SERVICE BULLETIN

No. 380

Piper Aircraft Corporation

Subject: Revised Pitch Servo Bridle Cable Installation

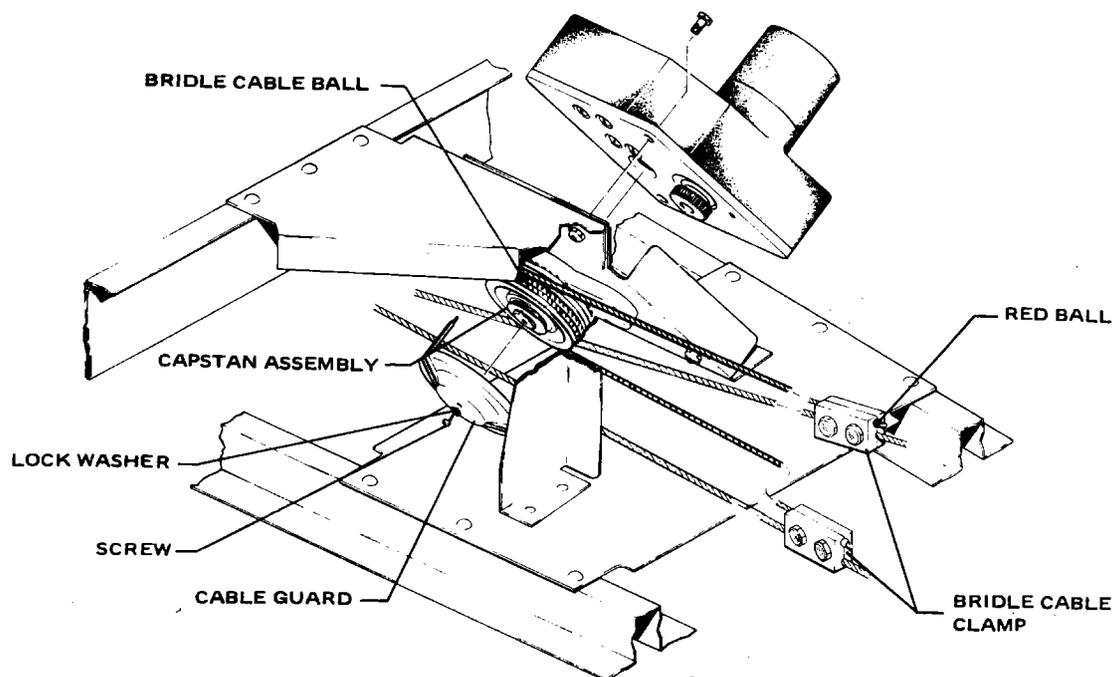
Purpose: The pitch servo bridle cable installation on recent production versions of the above referenced aircraft model has been revised. This revision requires a specified number of wraps of the bridle cable on the pitch servo capstan.

2. Ascertain the number of turns of the bridle cable around the pitch servo capstan. If the bridle cable is wrapped one (1) turn clockwise and one and one half (1 1/2) turns counterclockwise from ball on capstan, no further action is required. If installation is not in this configuration, proceed with step 3.

3. Remove cable guard from capstan assembly.
4. Remove bridle cable clamp from lower stabilator control cable.
5. Wrap free end of bridle cable one more turn counterclockwise on the capstan.

6. Attach bridle cable to lower stabilator control cable with bridle cable clamp previously removed.
7. With control wheel in neutral position, as defined in the Aztec Service Manual (P/N 753 564), loosen both bridle cable clamps so they slide on the control cables with some friction.

8. Rotate capstan as required to align the bridle cable ball in the capstan slot as shown in above sketch. Verify bridle cable is wrapped one turn clockwise and one and one half turns counterclockwise from ball on capstan.

10. Check for clearance of bridle cable clamps by moving the control wheel throughout its total travel and verify bridle cable is properly wrapped on the capstan as shown in above sketch.
